Troy School District

**RFP #2425-09 - Addendum #1
BP#2B High School Athletics - Phase #2
January 21st, 2025**

Troy Schools District – RFP #2425-09 BP#2B High School Athletics Renovations - Phase #2

Addendum #1 Bidder Clarifications

LD1.08

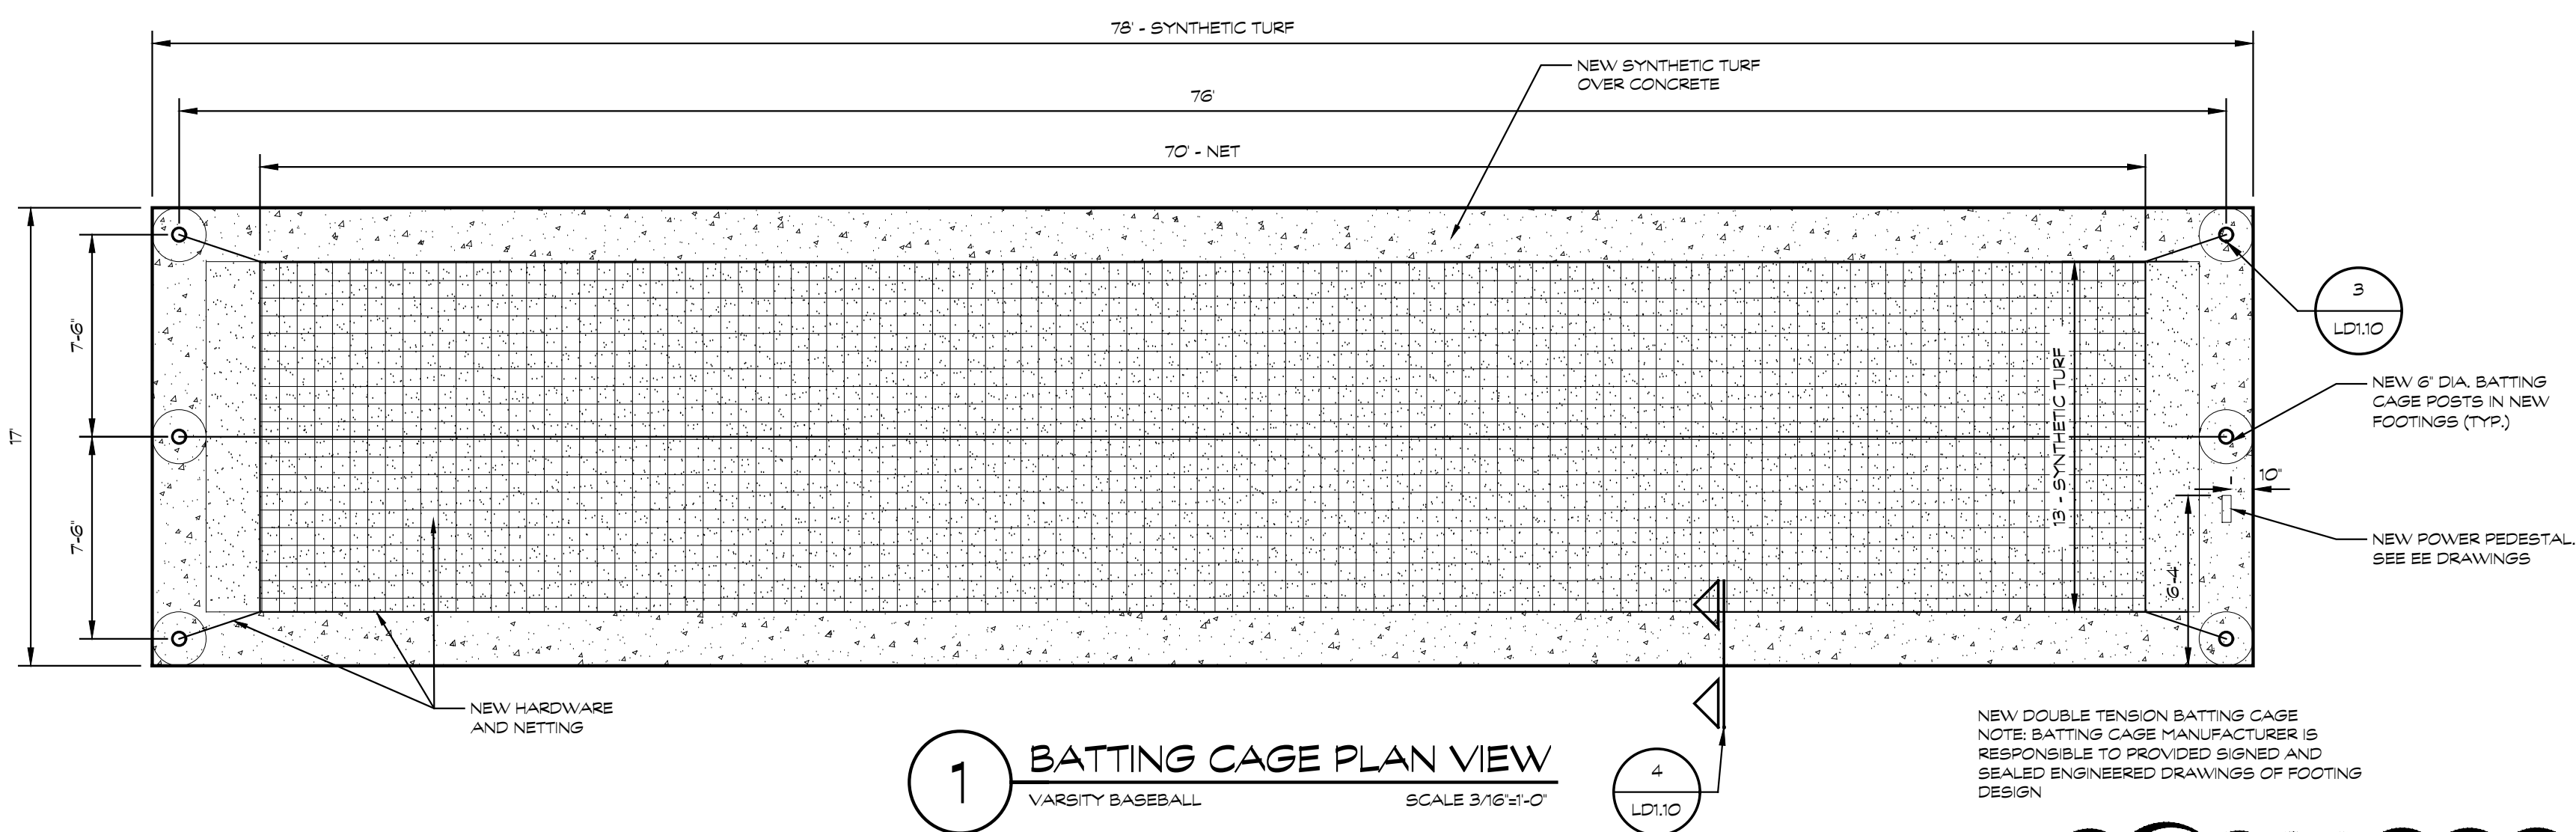
- A. Added note clarifying the intent for post sizes on gates larger than 12' as indicated.
- LD-10 Refer to Drawing No. LD1.08 (reissued):
 - A. Revised details; moved JV dugout details from different LD sheet onto sheet as indicated.

- B. Revised details; backstop detail numbers are reordered as indicated.
- LD-11 Refer to Drawing No. LD1.09 (not reissued):
 - A. Revised bullpen drain tile diameter to 6".

PROJECT NO.
22103D
DRAWING NO.
LD1.10

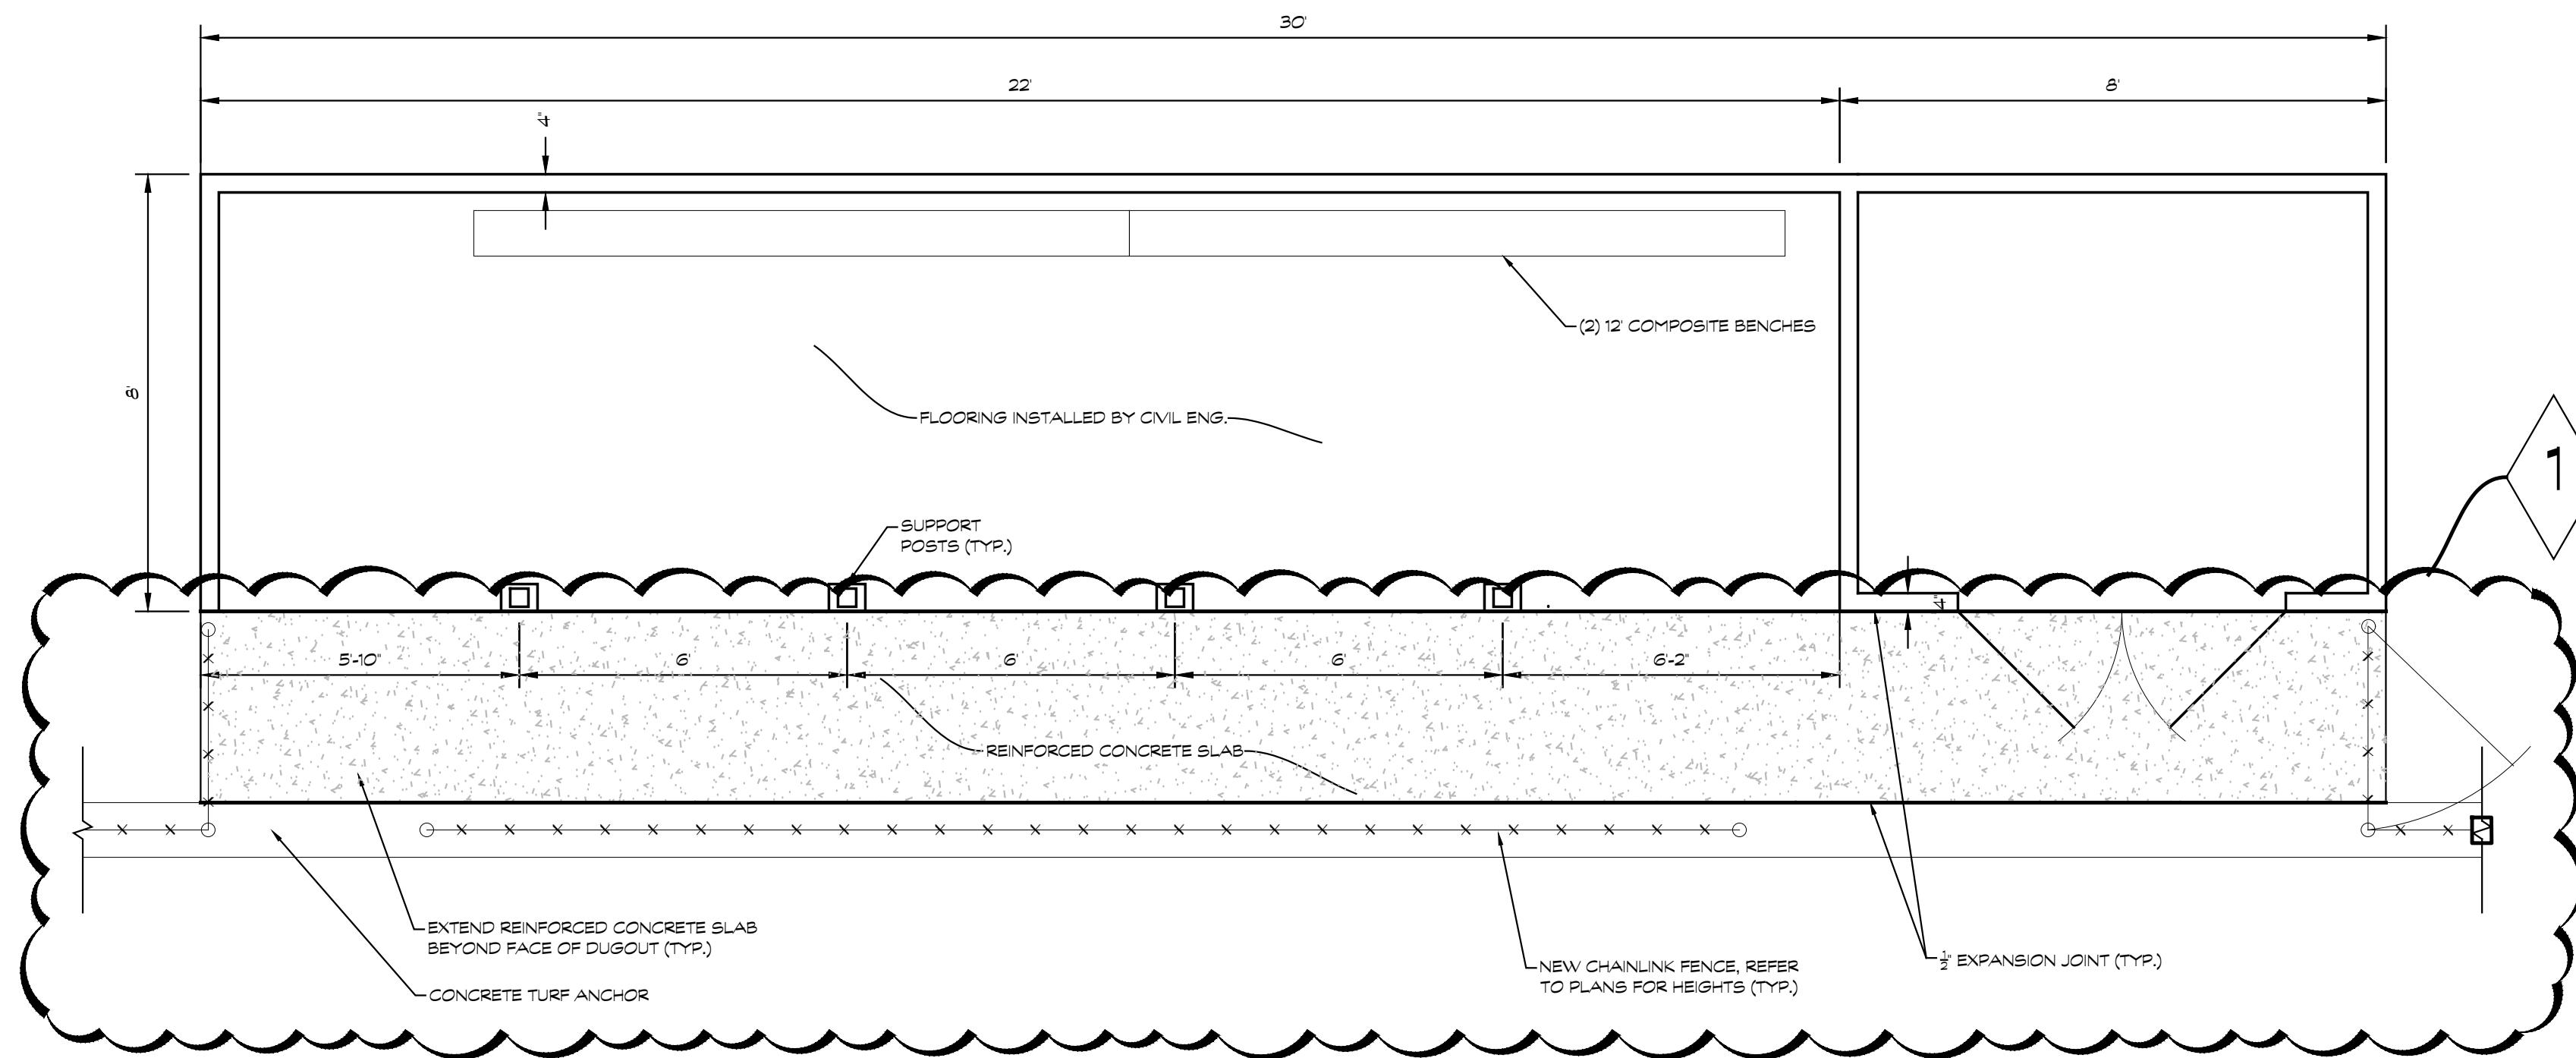
Q: Does the fence lines at both the JV baseball & softball fields require a curb or concrete maintenance strip. The grading plan gives us T.O.C. elevations. Please clarify.

Q: Please clarify what areas that require turf curbs. Do we need to include a turf curb in front of the poured in place wall that is shown on C3.0 and detailed on C9.0 (Troy Athens High School)?

- LD-12 Refer to Drawing No. LD1.10 (reissued):
 - A. Added section details for various finish grade conditions between athletic fields and site grading as indicated.

A: At JV bullpens, the chainlink fence surrounding the bullpen shall include a curb on all sides. There is no curb required for fence beyond limits of bullpen. Refer to Sheet LD1.09 and LD1.10. Reference to Addendum #1.

A: All turf athletic fields will require a concrete turf anchor at perimeter. Refer to Sheet LD1.10, Detail #9 issued with Addendum #1.
